ADDENDUM

ADDENDUM NO.: 02

PROJECT NAME: Emiliano Zapata Academy Annex

DATE OF ISSUE: August 23, 2017

DRAWING NO.
A3.2

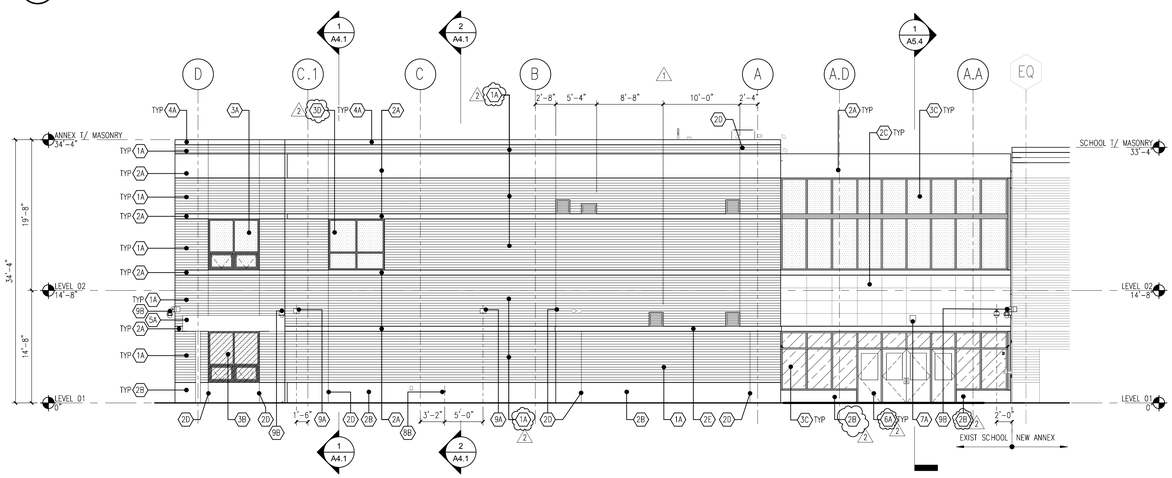
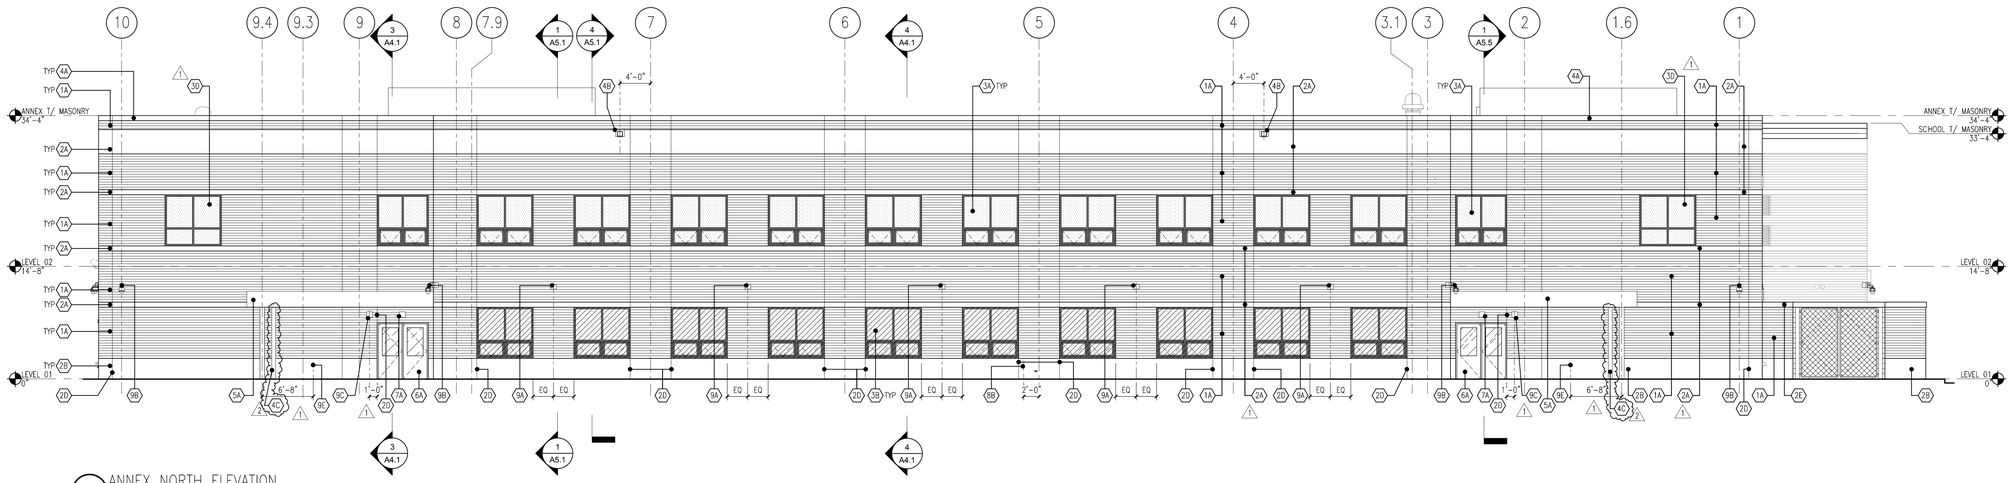
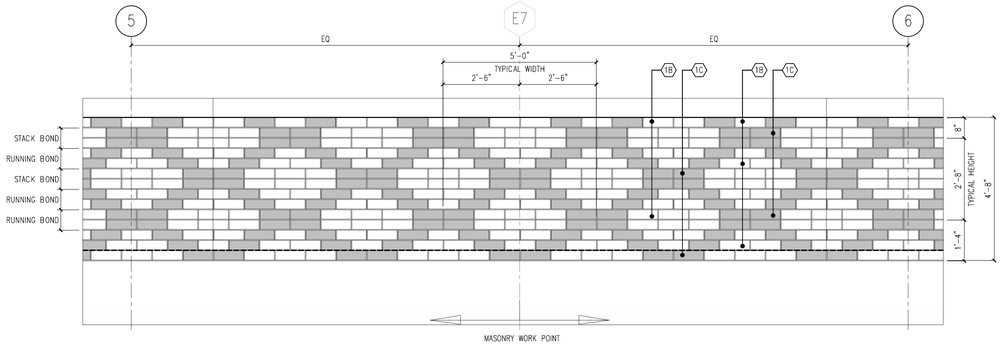
Change 33 SHEET A3.2 Partial Building Elevations – REVISED Keynote 2B in West Elevation adjacent to Column Line A.D.

Change 34 SHEET A3.2 Partial Building Elevations – ADDED Keynote 3F to Elevation Keynote Legend indicating aluminum frame storefront windows with security screens.

Change 35 SHEET A3.2 Partial Building Elevations – ADDED Keynote 9F to Elevation Keynote Legend indicating an electric bell.

Change 36 SHEET A3.2 Partial Building Elevations – ADDED Keynote 3F to East Elevation between Column lines B and C indicating aluminum frame storefront windows with security screens.

Change 37 SHEET A3.2 Partial Building Elevations – ADDED Keynote 9F to East Elevation between Column lines C and C.1 indicating an electric bell.

Change 38 SHEET A3.2 Partial Building Elevations – REVISED location of electric bell and security camera between Column lines C and C.1 in East Elevation.

DRAWING NO.
A3.3

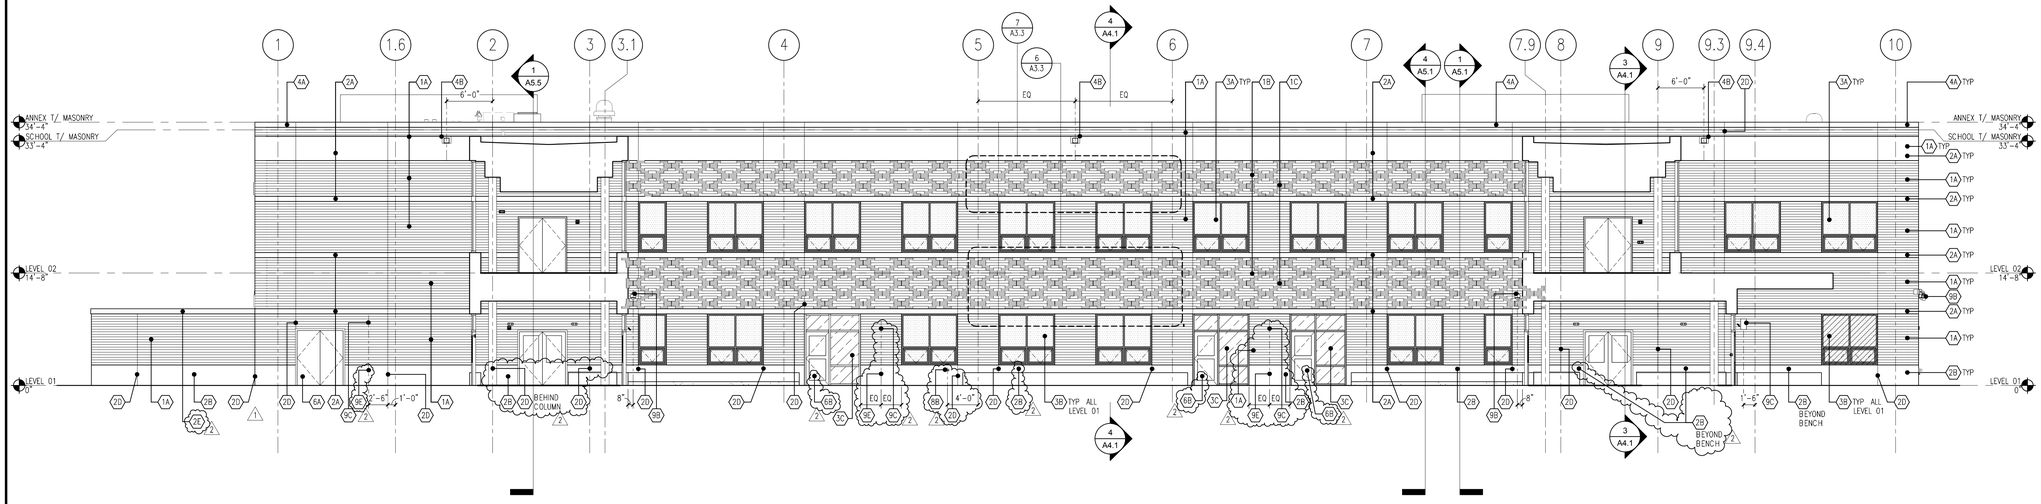
Change 53 SHEET A3.3 Partial Building Elevations – REVISED 2B (Beyond Bench) tag in detail 1.

Change 54 SHEET A3.3 Partial Building Elevations – ADDED Keynote 6B to three Enclosed Courtyard doors.

Change 55 SHEET A3.3 Partial Building Elevations – REVISED location of speaker and Keynote 9C in detail 1 between column lines 6 and 7.

Change 56 SHEET A3.3 Partial Building Elevations – ADDED electrical outlet and Keynote 9E in detail 1 between column lines 6 and 7.

Change 57 SHEET A3.3 Partial Building Elevations – ADDED Keynote 2B in detail 1 east of column line 5.

Change 58 SHEET A3.3 Partial Building Elevations – REVISED hose bib location and ADDED Keynote 8B in detail 1 west of column line 5.

Change 59 SHEET A3.3 Partial Building Elevations – REVISED location of speaker and Keynote 9C in detail 1 between column lines 4 and 5.

Change 60 SHEET A3.3 Partial Building Elevations – ADDED electrical outlet and Keynote 9E in detail 1 between column lines 4 and 5.

Change 61 SHEET A3.3 Partial Building Elevations – REVISED Keynote 2D in detail 1 between column lines 2 and 3.

Change 62 SHEET A3.3 Partial Building Elevations – ADDED Keynote 2B in detail 1 between column lines 2 and 3.

Change 63 SHEET A3.3 Partial Building Elevations – REVISED Keynote 2E in detail 1 west of column line 1.

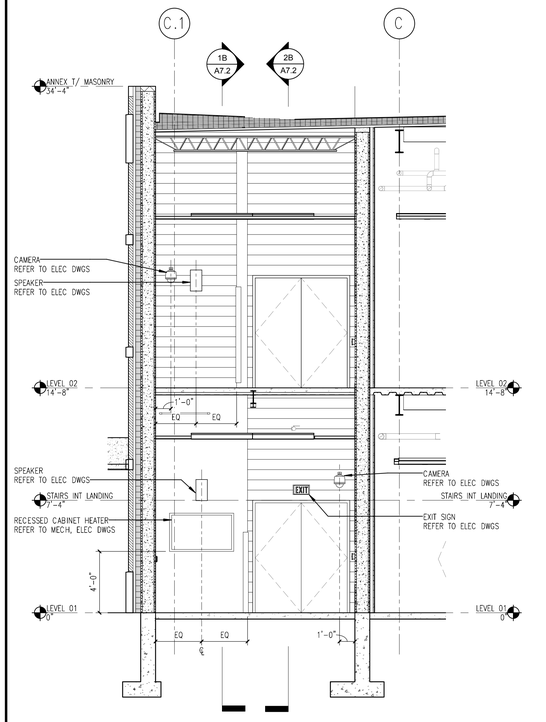
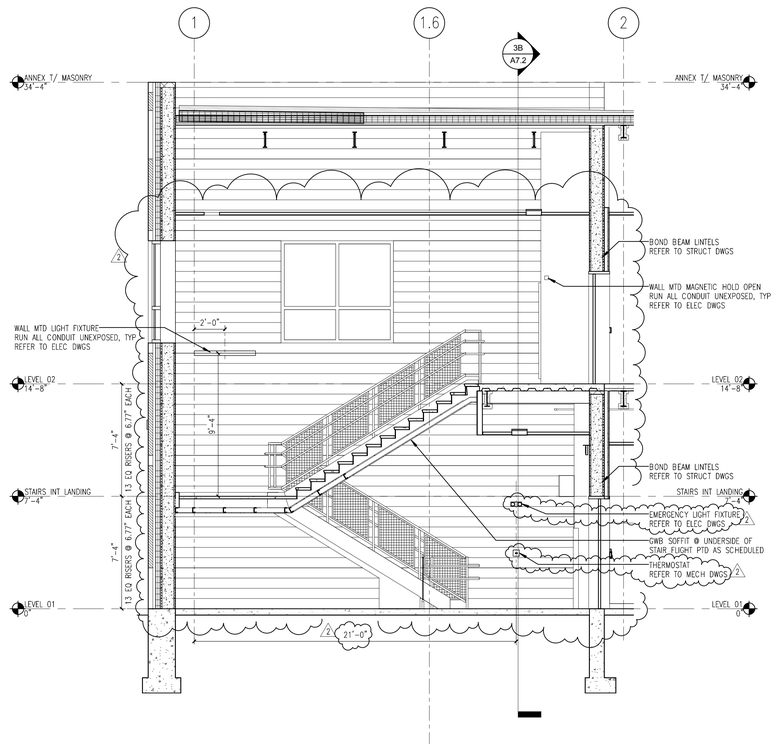
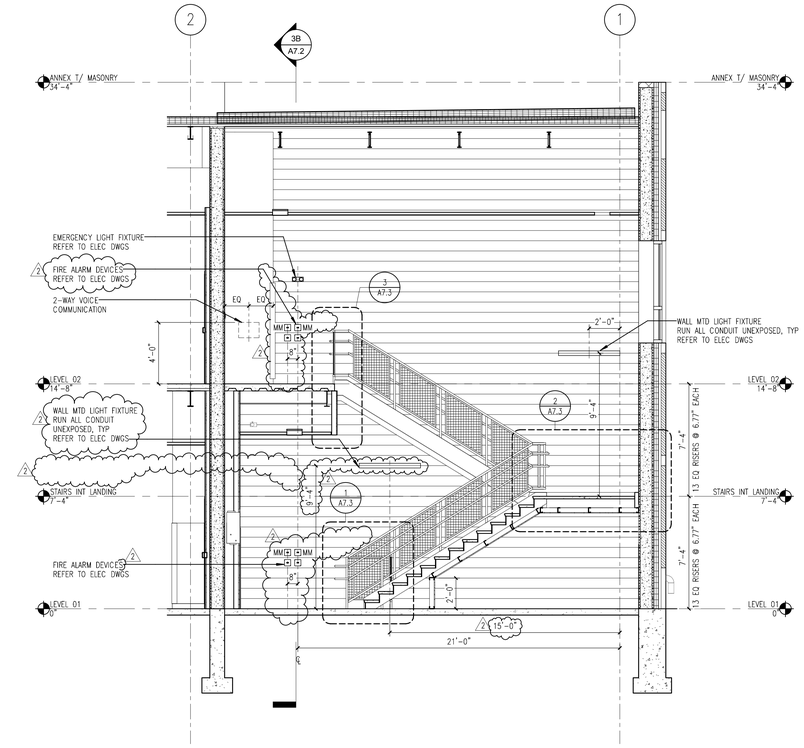
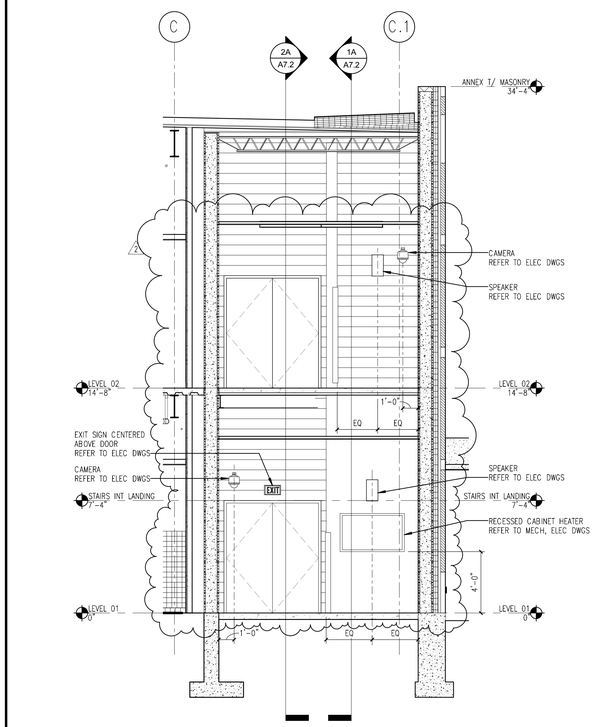
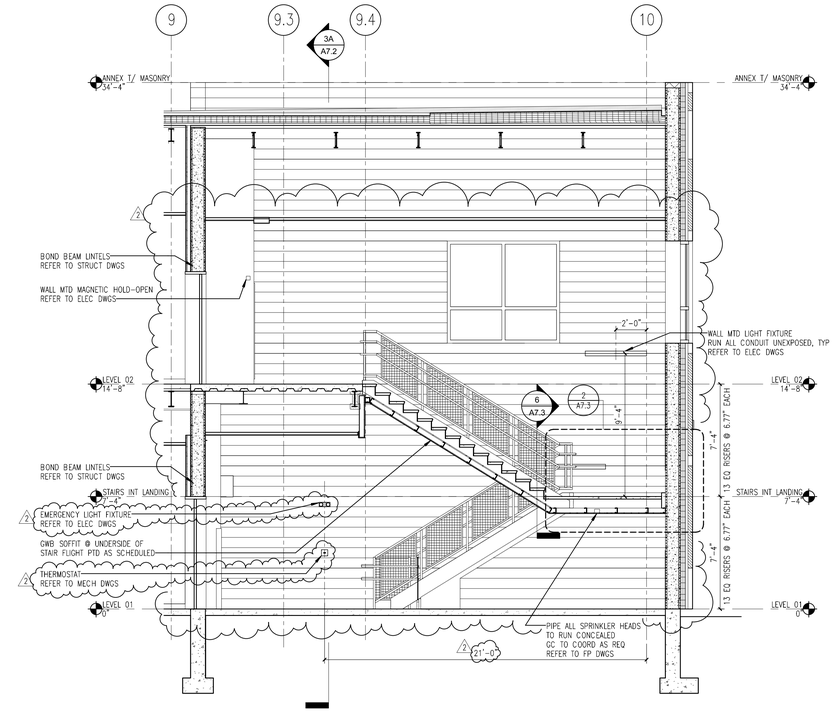
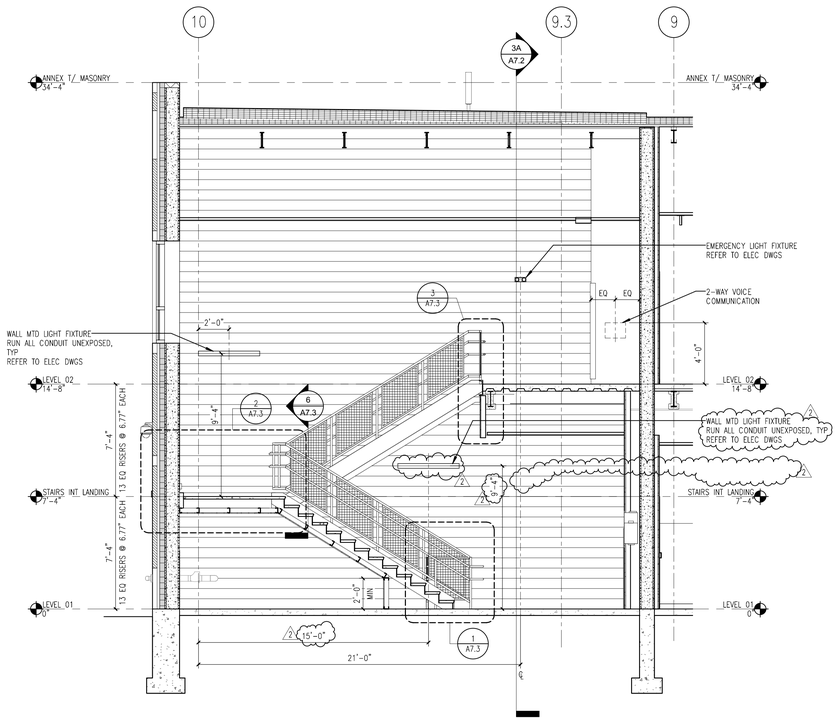
Change 67 SHEET A7.2 Enlarged Stair Sections – REVISED titles of details 1 and 2 to reflect the accurate direction of the section cuts.

Change 68 SHEET A7.2 Enlarged Stair Sections – REVISED location of emergency light fixture on first floor from north elevation to south elevation in Stairs A & B.

Change 69 SHEET A7.2 Enlarged Stair Sections – ADDED wall-mounted light fixture to the first floor south partition in Stairs A and B.

Change 70 SHEET A7.2 Enlarged Stair Sections – ADDED thermostat to the first floor north partition in Stairs A and B.

DRAWING NO.
A13.0

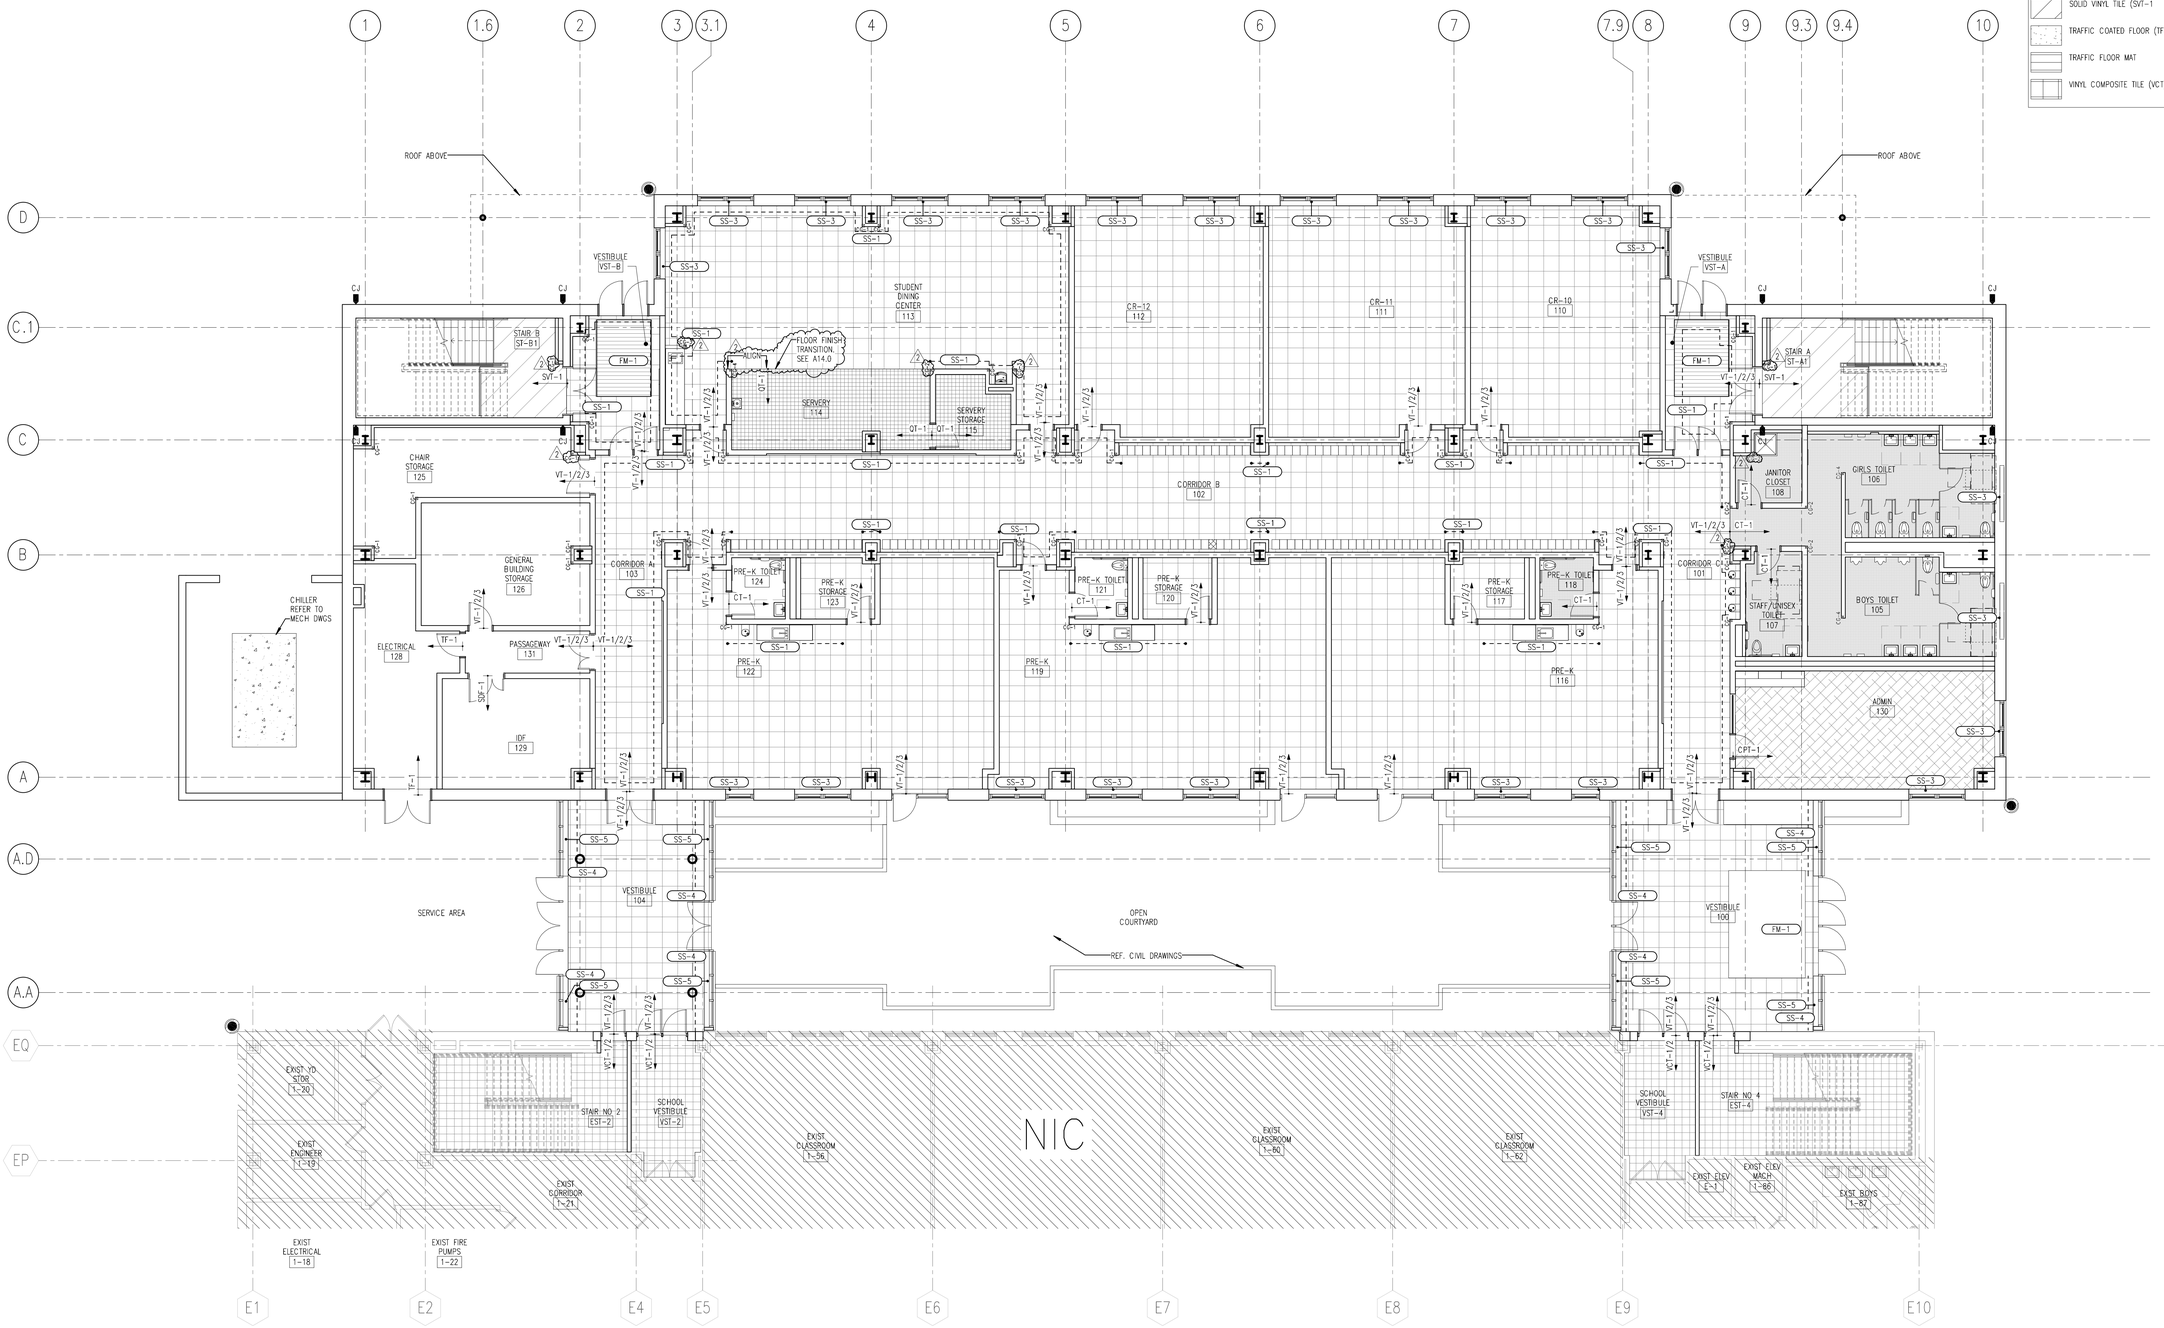
Change 91 SHEET A13.0 Finish Schedule, Legend and Finish Details – ADDED Finish Specifications numbers.

Change 92 SHEET A13.0 Finish Schedule, Legend and Finish Details – ADDED Finish Material GF-1 Glass Film.

Change 93 SHEET A13.0 Finish Schedule, Legend and Finish Details – REVISED Finish Material HPL-1 to PL-1.
